3.0 LIMITING CONDITION FOR OPERATION (LCO) APPLICABILITY

The information in this section of the reference ABWR DCD, including all subsections, is incorporated by reference with the following departure.

STP DEP 16.3-1

Figure B 3.3.1.4-1 ESF Actuation Channel Structure for Containment Isolation, ESF Support

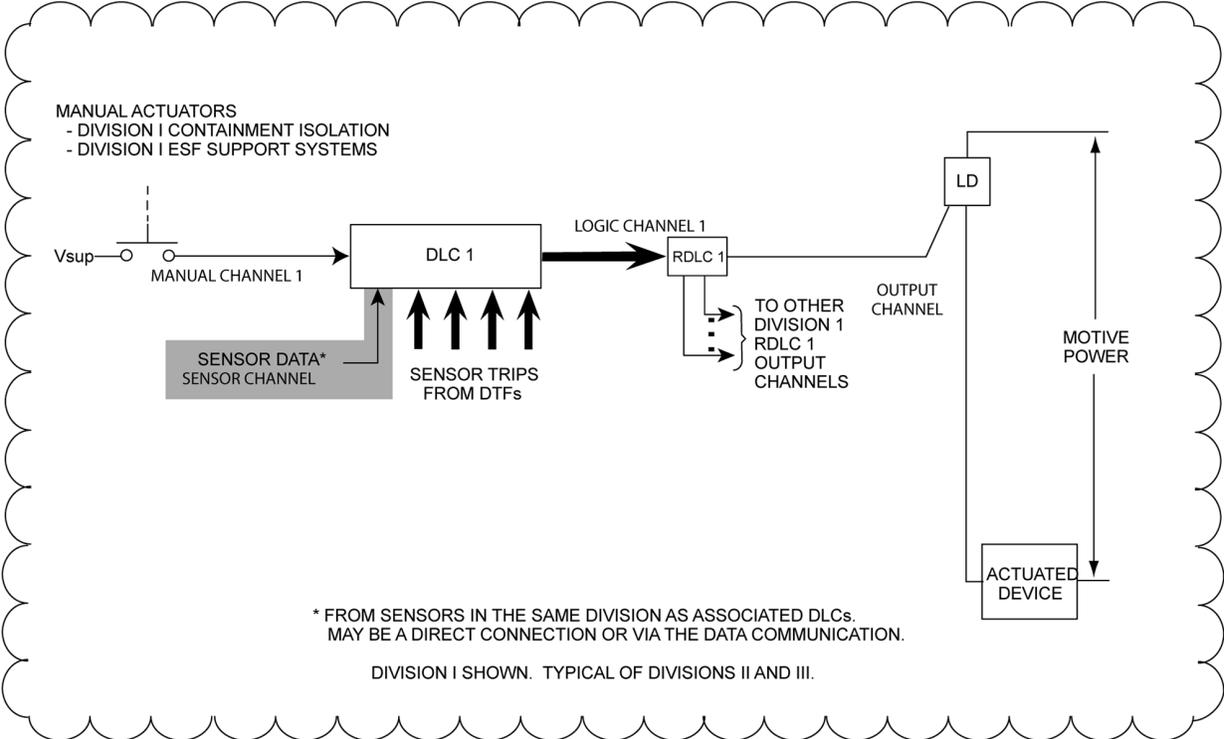
STD DEP T1 3.4-1 This figure replaces Figure B 3.3.1.4-1.

Figure B 3.3.1.4-2 ESF Actuation Channel Structure for LPFL B, C, HPCF B, RCIC

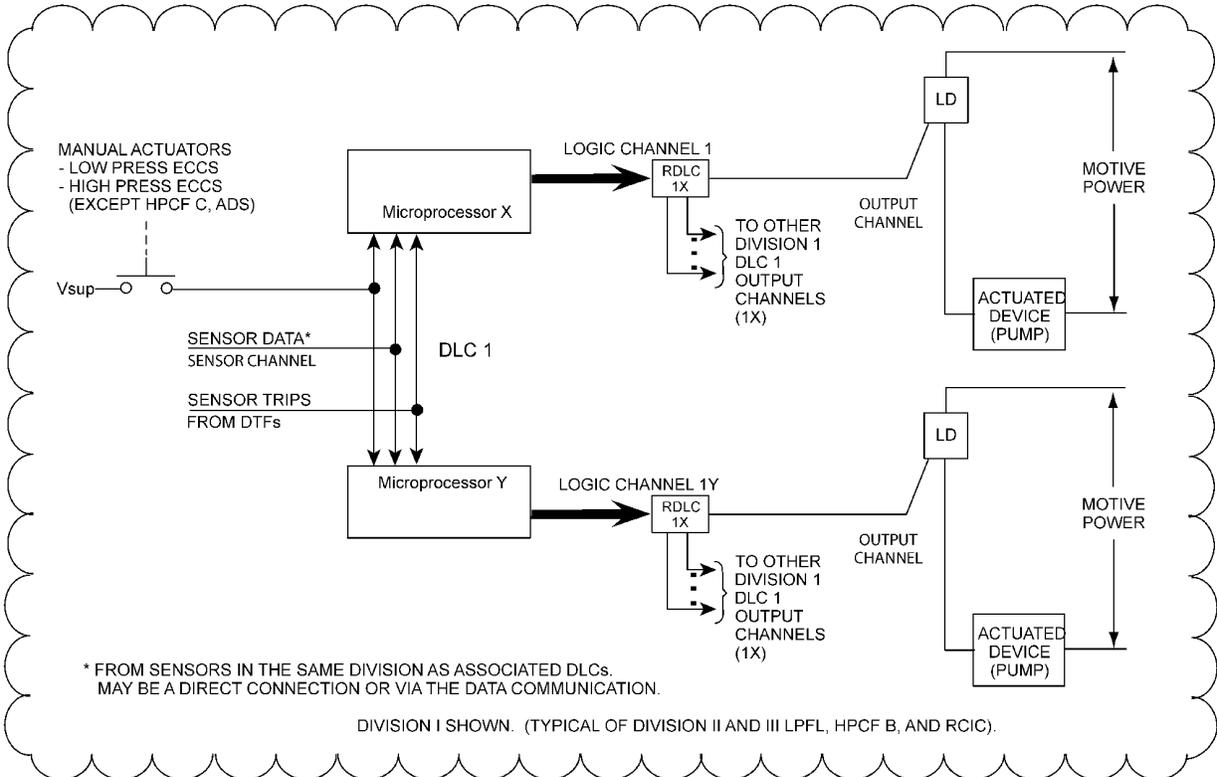
STD DEP T1 3.4-1 This figure replaces Figure B 3.3.1.4-2.

Figure B 3.3.1.4-3 ESF Actuation Channel Structure for HPCF C

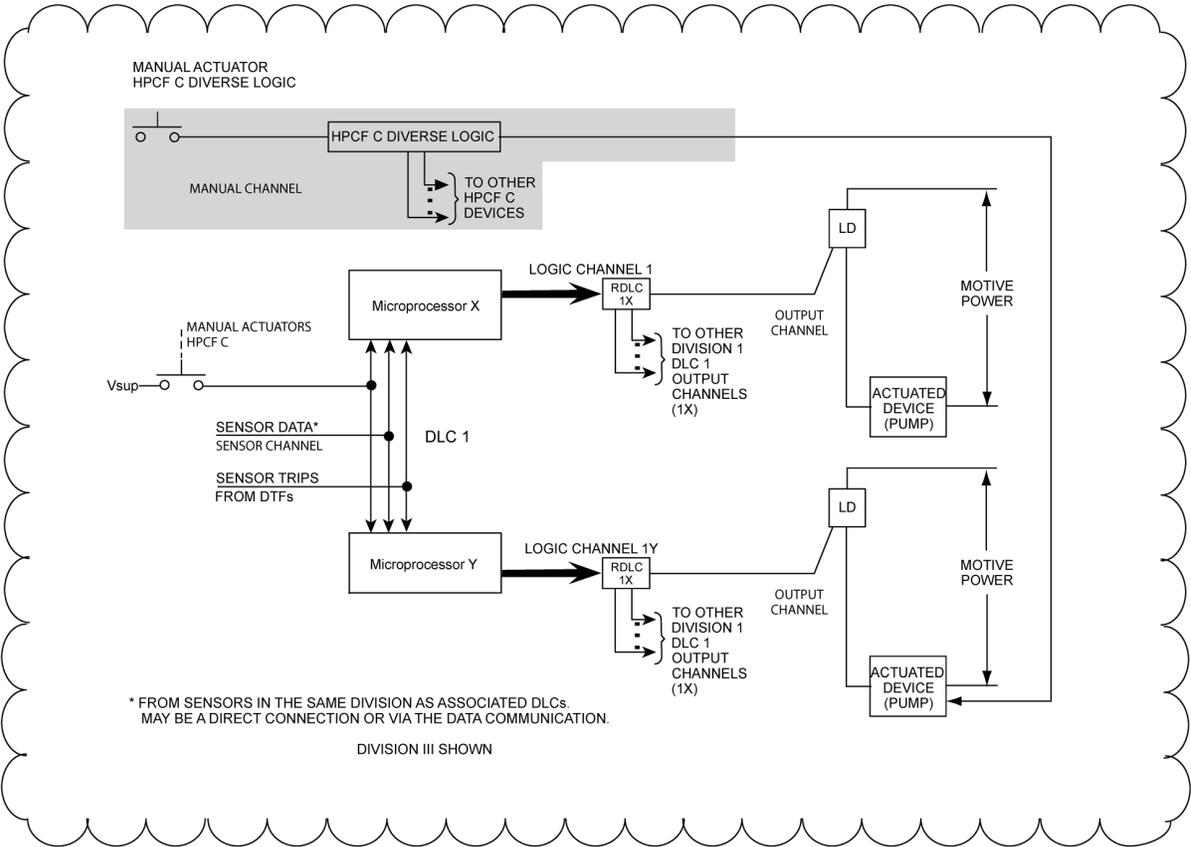
- Figure B 3.3.1.4-3 shows the hardwired manual channel for HPCF C diverse logic which applies only to division III.
- ~~The separate contacts from a A single switch operator are shown as~~ provides the manual initiation signal to separate both manual initiation channels.

The HPCF C Diverse Logic Manual Initiation channel completely bypasses the SSLC channels (see figure B 3.3.1.4-3) and provides direct control of the actuated devices. One manual pushbutton causes HPCF C to align for injection and initiates the pump start sequence.

STD DEP T1 3.4-1 This figure replaces Figure B 3.3.1.4-3.

Figure B 3.3.1.4-4 ESF Actuation Channel Structure for ADS

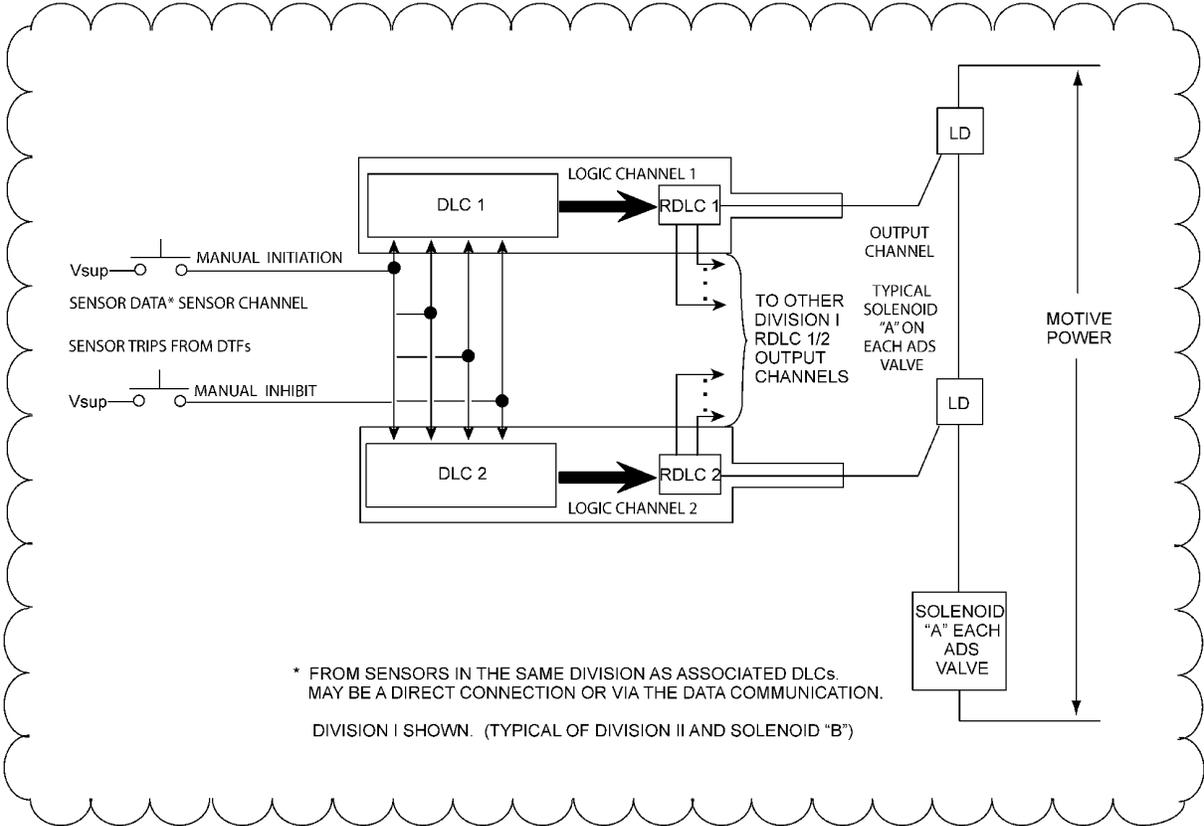
The ATWS Manual ADS Inhibit push button channels introduce signals into the ADS logic to provide manual ADS inhibit capability that is redundant to the automatic SENSOR CHANNELS. There is one push button for each ADS division trip system. ~~Each pushbutton has two contacts. Each member of the SLU pair~~ Both DLCs used to implement ADS within a division acquire data from ~~one of the contacts on the switch in its division~~ (see Figure B 3.3.1.4-4).

STD DEP T1 3.4-1 This figure replaces Figure B 3.3.1.4-4.

Figure B 3.3.1.4-5 ESF Actuation Channel Structure for RCW/RSWW Isolation

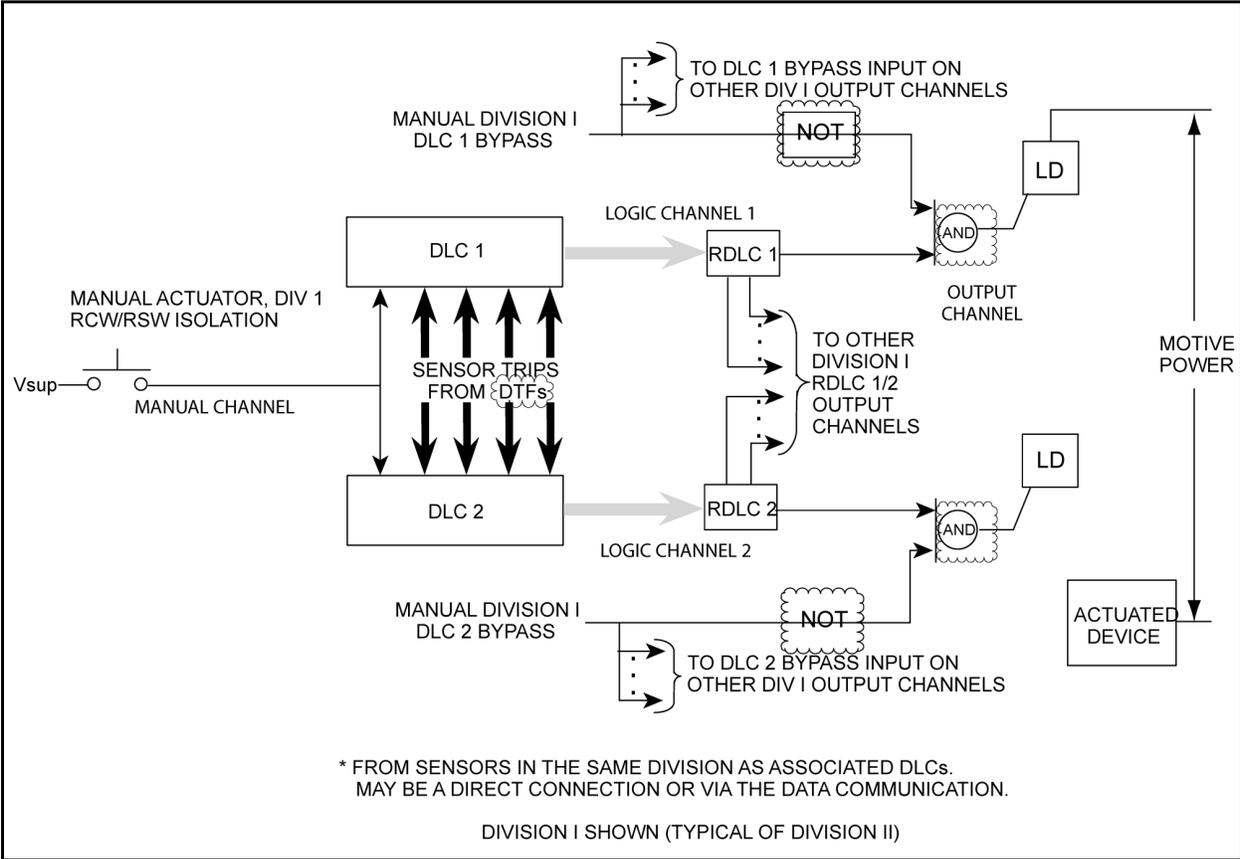
STD DEP T1 3.4-1 This figure replaces Figure B 3.3.1.4-5.
